SOLICITATION AMENDMENT MODIFICATION DE L'INVITATION

Title - Sujet Sea Containers	
Solicitation No. - N° de l'invitation W355B-207222/A	Amendment No. - N° modif. 004
Client Reference No. - N° de référence du client W355B-20-7222	Date 2019-11-28
GETS Reference No. - N° de référence de SEAG PW-SHAL-406-10814	
File No. - N° de dossier HAL-9-83081 (406)	CCC No./N° CCC - FMS No./N° VME
Solicitation Closes - L'invitation prend fin at - à 02:00 PM on - le 2019-12-18	Time Zone Fuseau horaire Atlantic Standard Time AST
F.O.B. - F.A.B. Plant-Usine: <input type="checkbox"/> Destination: <input checked="" type="checkbox"/> Other-Autre: <input type="checkbox"/>	
Address Enquiries to: - Adresser toutes questions à: Matheson, Valerie	Buyer Id - Id de l'acheteur hal406
Telephone No. - N° de téléphone (902) 403-6236 ()	FAX No. - N° de FAX (902) 496-5016
Destination - of Goods, Services, and Construction: Destination - des biens, services et construction:

AMENDMENT 004 is issued to address the following:

TITLE:	SHIPPING CONTAINER LAYOUT	APPROVED:	M MacDONALD
DESIGNED:	M MacDONALD	SCALE:	40:1
DRAWN:	M MacDONALD	DWG. NO.	4603591-001

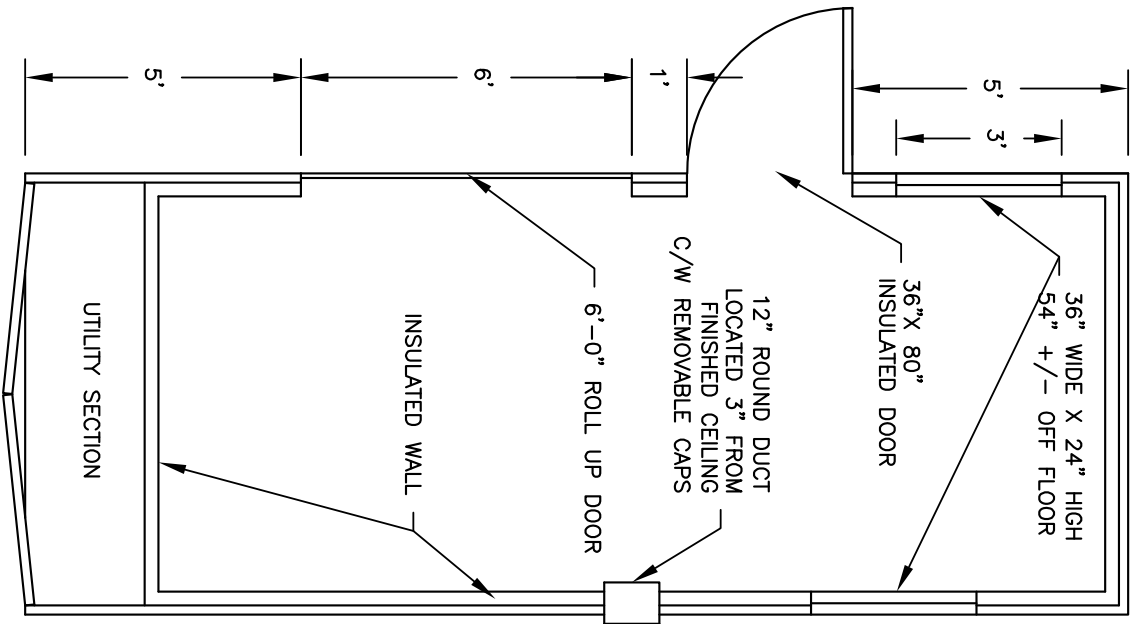
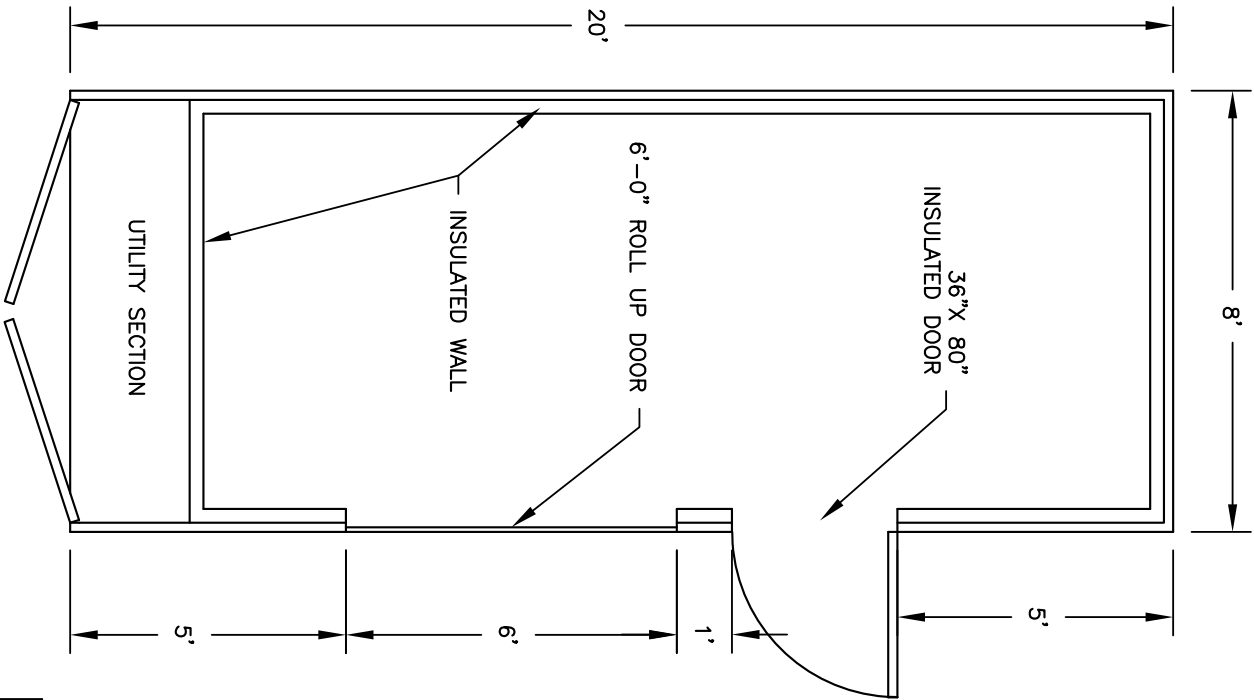
Q8: Can the customer provide their suggested door window, heater 12 inch outlet layouts. Pencil sketch works.

A8: **See attached.**
